Banaglaow Rd - Pedestrian refuge and enhancement of existing pedestrian crossing at roundabout

Pedestrian refuge No 1

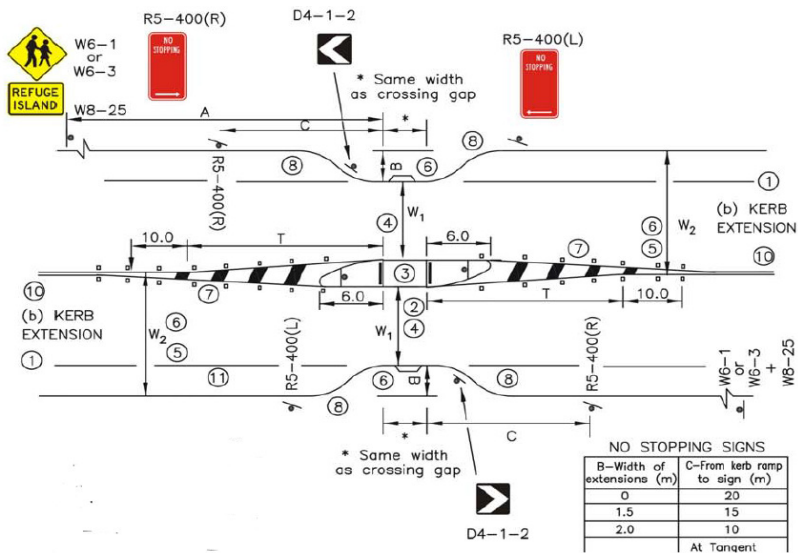
Best suitable location near RSL age care centre and bus stops. Further south or north pedestrian refuge will clash with auxiliary lanes and driveways

Pedestrian refuge to be as per AS1742.10 and RMS TDT 2011/01a

Existing crossing is lacking hand rail, delineation, reflective markers, warning signage, line marking and raised reflective markers.

Install all of the above to enhance safety on existing crossing
